MEMORANDUM

Reference: PPSSWC-229 (Council Reference: DA22/0131)
To: Sydney Western City Planning Panel
From: Robert Walker, Senior Development Assessment Planner
Date: 1 December 2022
Subject: **Construction of a Warehouse (comprising of 4 occupancies) and associated works at No. 68 Lockwood Road, Erskine Park**

Figure 1: Applicant's Fencing plan as lodged with the DA (**Appendix B**).

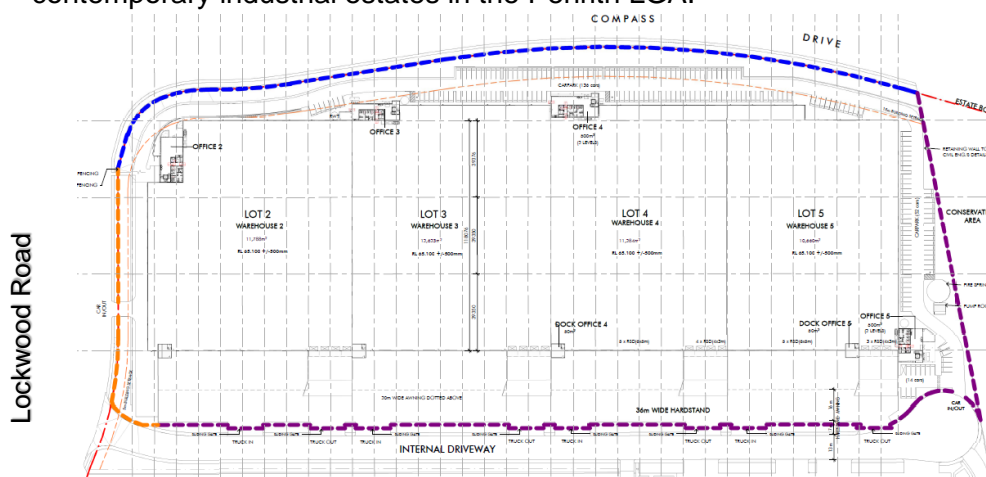
Submitted plan no. DA062 Fencing Plan, revision 5 (**Appendix B**) which was lodged with the DA, indicates that metal chain link fence being 1.8m high with 3 rows of barbed wire over, is proposed for the frontage of the site to Compass Drive (refer blue line in **Figure 1** below) and to the intersection with Lockwood Road. The plan also indicates that black powder coated palisade fencing (refer orange line in below) is proposed to the remainder of the site's frontage to Lockwood Road.

Council maintains that fencing in the estate must be of high quality and be setback from the site's boundaries and be within the landscaping, in accordance with the requirements of Council's DCP, and so as not to detract from the high-quality design anticipated for contemporary industrial estates in the Penrith LGA.

In email dated 29 November (**Appendix A**) the applicant proposes to provide the higher quality black palisade fencing to the site's frontage to Lockwood Road and for a 30m portion of the site's frontage to Compass Drive. No plan was provided.

Council maintains that the black palisade fencing shall be provided to the full length of the site's frontage noting that the proposed additional 30 metres of palisade fencing would likely not span the site's arc corner boundary to the intersection. Low quality fencing will be a detracting element in the site's context, particularly if located on the boundary line. No further plans are provided which detail where the fencing will be located within the landscaping setback, and the current plan indicates that fencing is positioned on the site boundary.

Notwithstanding the above, if the Panel is of a mind to support the use of black plastic-coated chain link fencing for a portion of the site's frontage to Compass Drive, Council would recommend that it be setback a minimum of 2m within the landscaping of the site and is not to be installed along the site's frontage to the roundabout or be within 100m of the intersection arc.

To ensure fencing and landscaping is designed and installed in accordance with the intent of the DCP, it is recommended that the applicant provide detail of the materials, locations and extent of fencing as part of amended Condition 2, which relates to landscaping. Refer **Table 1** below for amended Condition 2. The amendments are to be approved by Council and not a private certifier.

Council also recommends that fencing plan no. DA062 be deleted from the stamped approved plans referenced in Condition 1, as fencing will be managed by recommended amended Condition 2.
